POST TENDER ADDENDUM No. 02

Smithers Regional Airport
Terminal Upgrade and Expansion
Smithers, BC Contract 2017-11
July 21th, 2017 MW #16-181

STRUCTURAL POST TENDER ADDENDUM NO. 1

Revisions to Structural Drawings as Issued for Tender dated 2017/04/11:

3 BUILDING SECTION - TYPE 5
S3.2 1 : 50

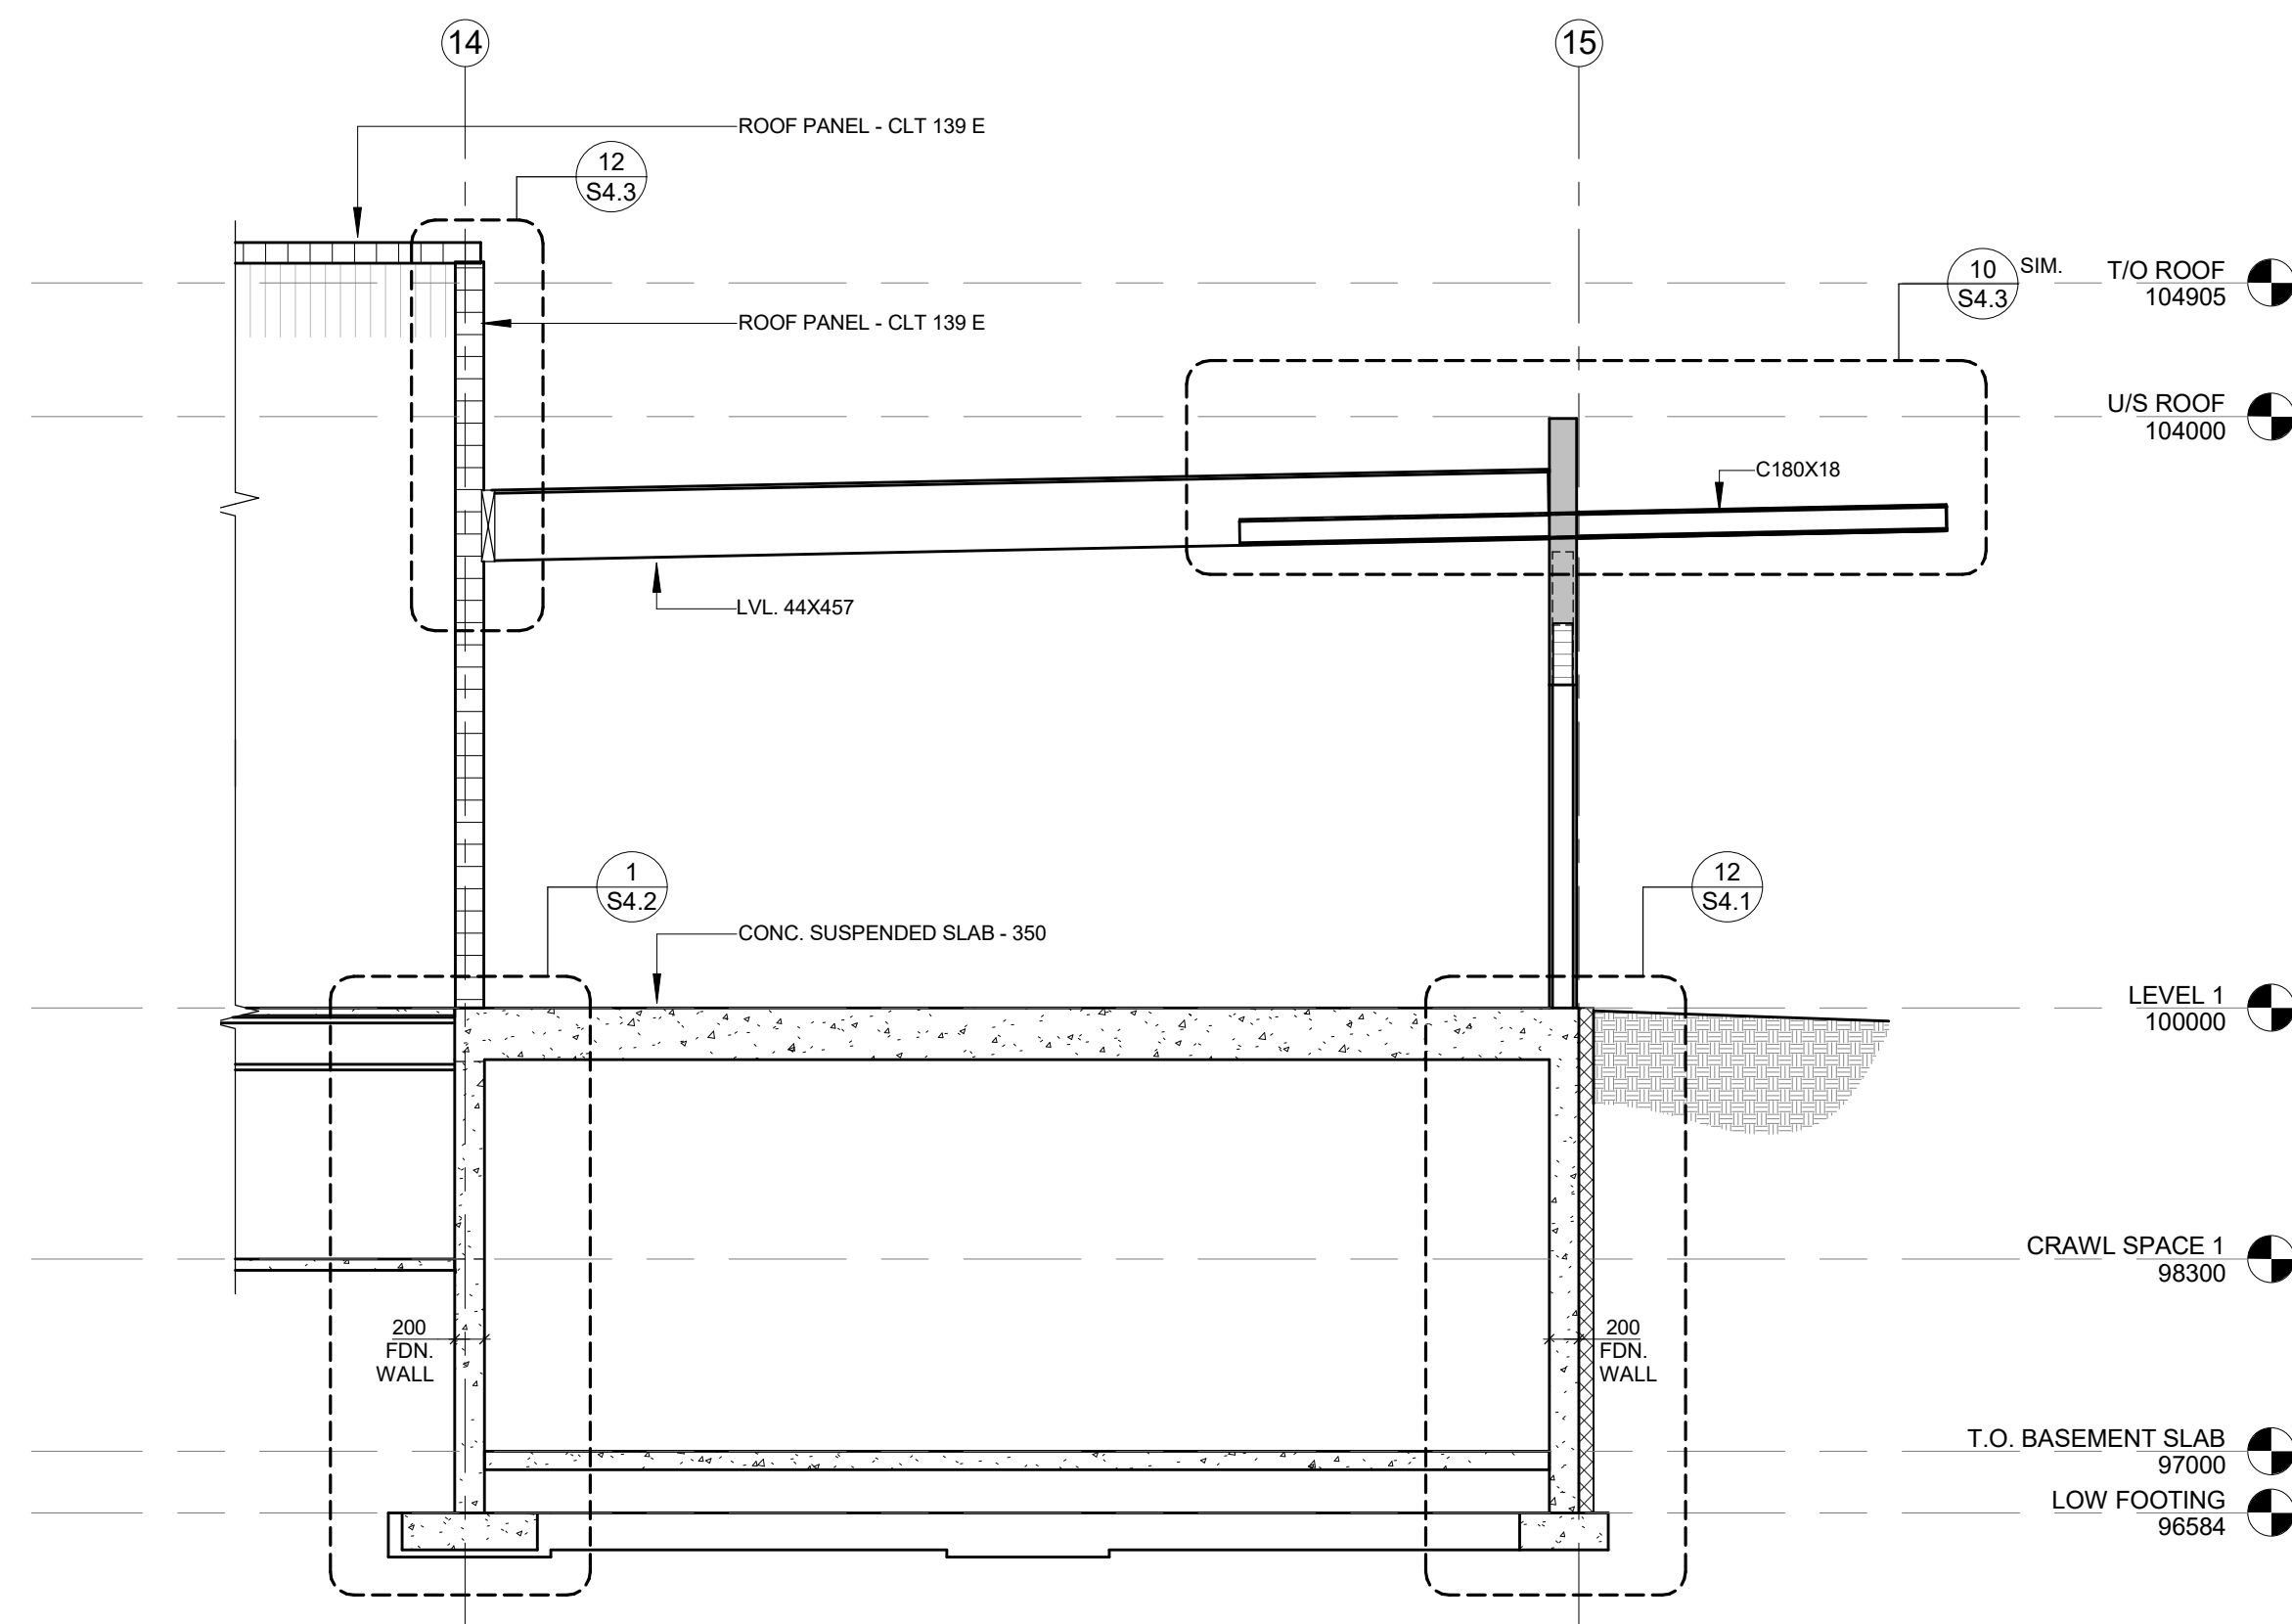
6. SHEET S3.2 – BUILDING SECTIONS (VPG ITEM #8)

- i. Revise** NLT Roof and Canopy panels can be used as an alternative for CLT Roof and Canopy panels – submit alternative design to Kerkhoff Engineering for approval

8 POST SADDLE DETAIL
S4.1 1 : 10

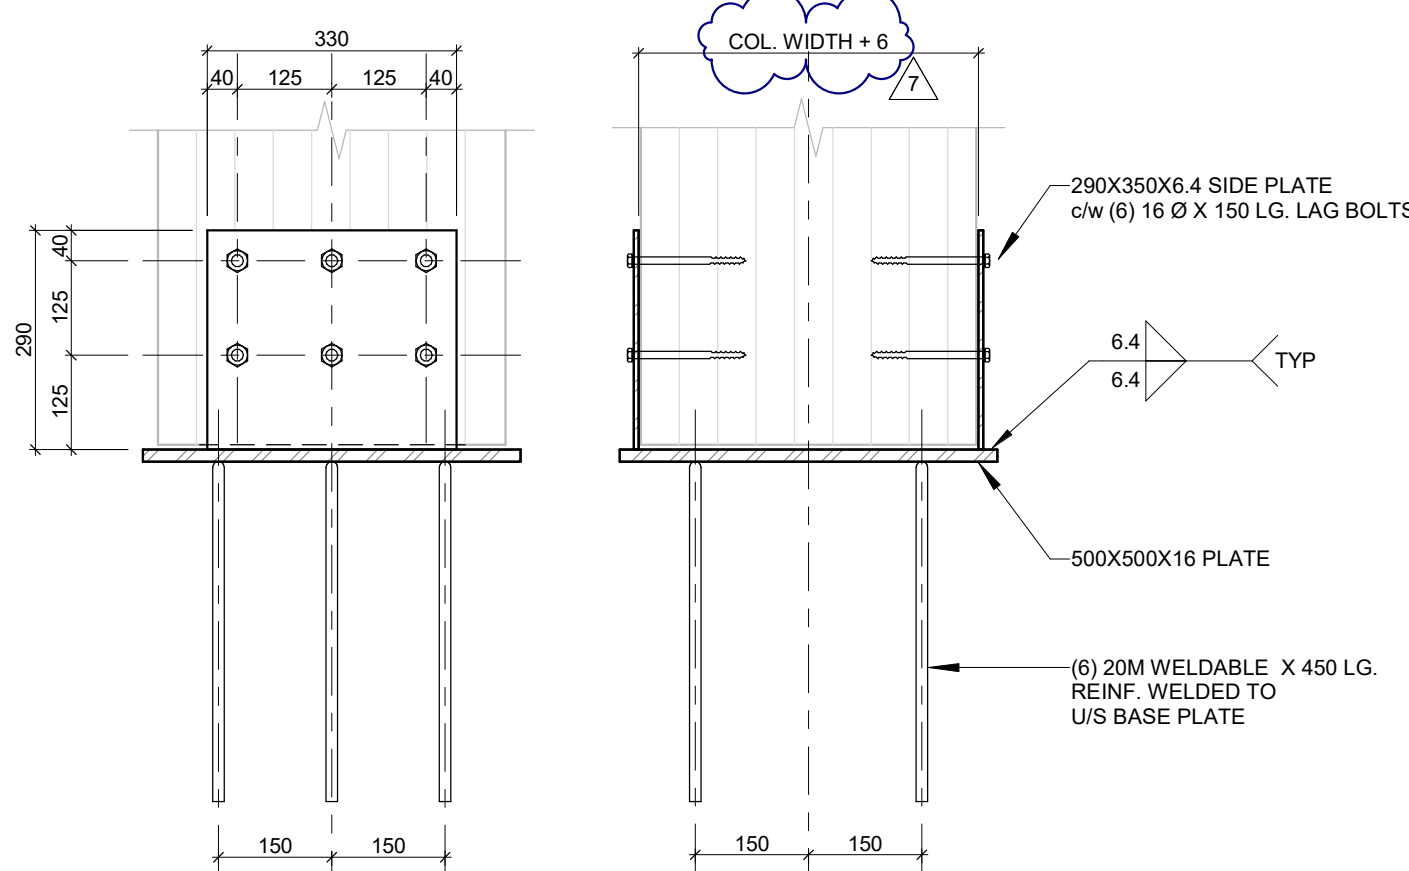
- i. Revise** Post Saddle Detail (8/S4.1)

5 ROOF PANEL TO GLULAM BEAM CONNECTION
S2.3 1 : 25

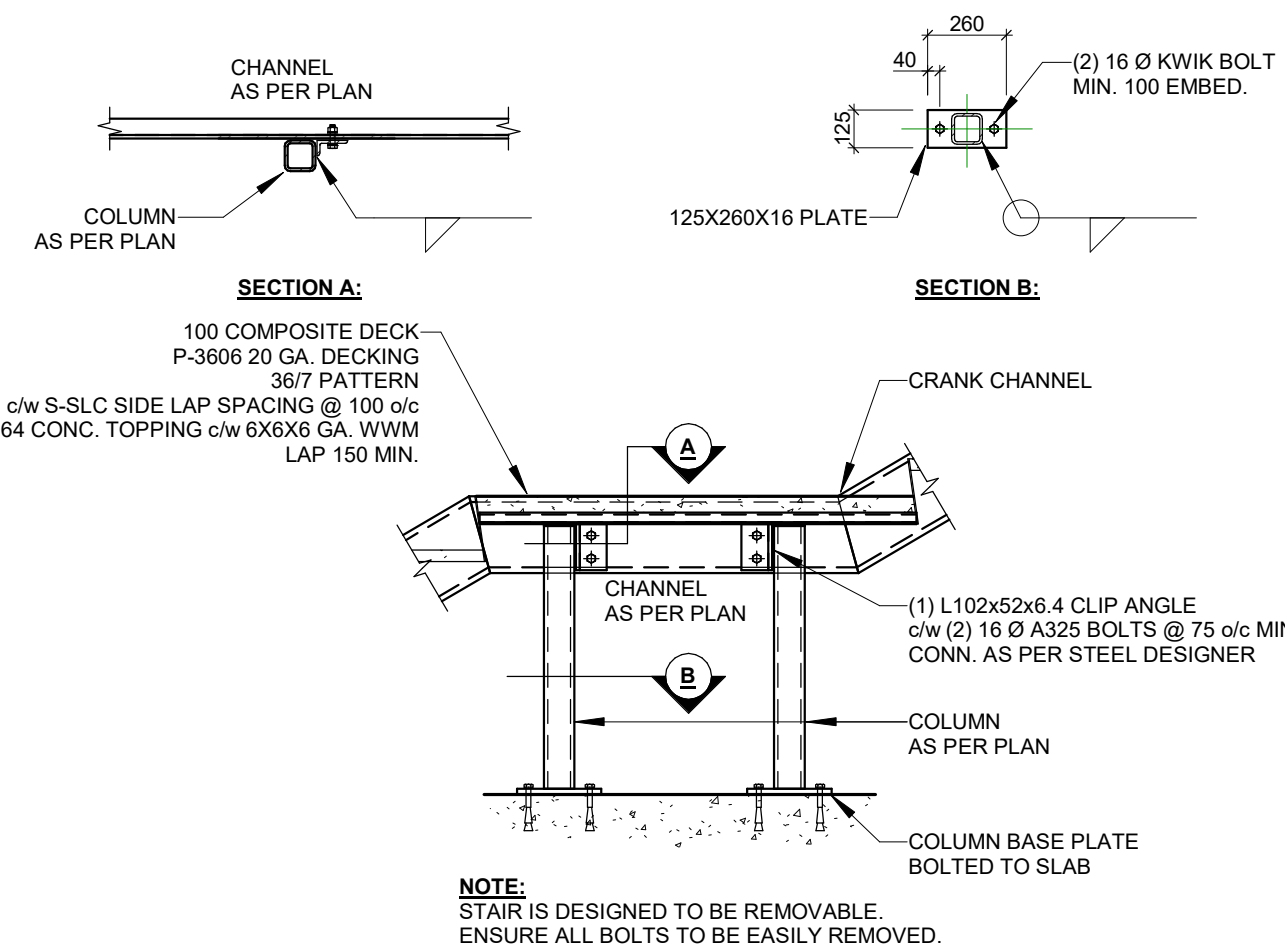
- i. Revise** Roof Panel to Glulam Beam Connection (5/S4.5)
- ii. Delete** HSS Column to Conc. Wall Base Plate Detail (6/S4.5)
